Access Compliance Report

Intersection ID: 23079	Main Street: KINGSMEADE_CT	Cross Street: MOORLAND_DR	Location: NE
ADA ID: D1B1B324B69A	Ramp Type: PerpDiag	Initial Pass/Fail: Fail	Overall Compliance: No
Severity Score: 10			
Codes/Mitigation Info/Possible Solution		Field Measurements/Component Compliance

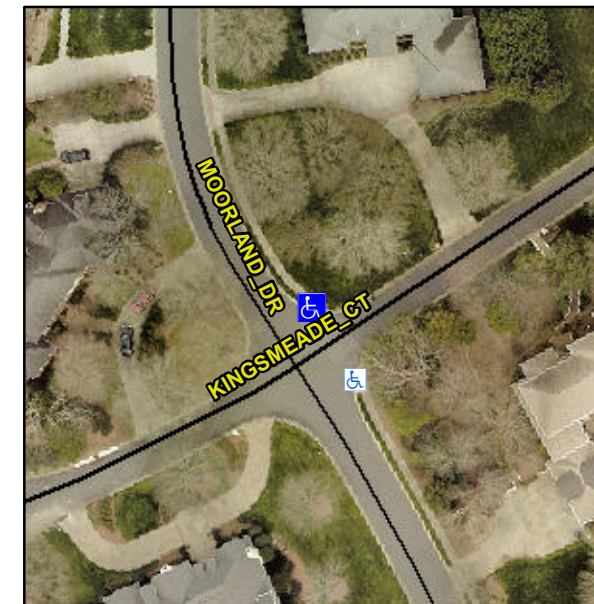
Not Found, R304.5.1, R304.5.3

Compliance	Description	Data	Compliance	Description	Data
N/A	Ramp Length (in)	52.0	Yes	Ramp Slope (%)	5.8
No	Ramp Width (in)	47.0	No	Ramp XSlope (%)	2.7
N/A	Flare Type LT	N/A	N/A	Flare Type RT	N/A
N/A	Flare Slope LT (%)	N/A	N/A	Flare Slope RT (%)	N/A
N/A	Flare Traversable LT?	N/A	N/A	Flare Traversable RT?	N/A
N/A	Landing Length (in)	N/A	N/A	DWS Provided?	N/A
N/A	Landing Width (in)	N/A	N/A	DWS Contrast?	N/A
N/A	Landing Slope (%)	N/A	N/A	DWS Length (in)	N/A
N/A	Landing X Slope (%)	N/A	N/A	DWS Full Width?	N/A
N/A	Landing Curb? (Y/N)	N/A	N/A	DWS Offset (in)	N/A
N/A	Shared Landing?	N/A			
N/A	Gutter Ponding?	N/A	N/A	Gutter Slope (%)	N/A
N/A	Gutter Lip Ht (in)	N/A	N/A	Gutter X Slope (%)	N/A
N/A	Painted X Walk1?	No	N/A	Painted X Walk2?	No
	X Walk 1 Direction	To W		X Walk 2 Direction	To S
N/A	X Walk 1 Width (in)	N/A	N/A	X Walk 2 Width (in)	N/A
	X Walk 1 Slope (%)	0.2		X Walk 2 Slope (%)	2.7
	X Walk 1 X Slope (%)	1.8		X Walk 2 X Slope (%)	1.3

Remove & Replace Curb Ramp With Two New Directional Ramps or Equivalent.
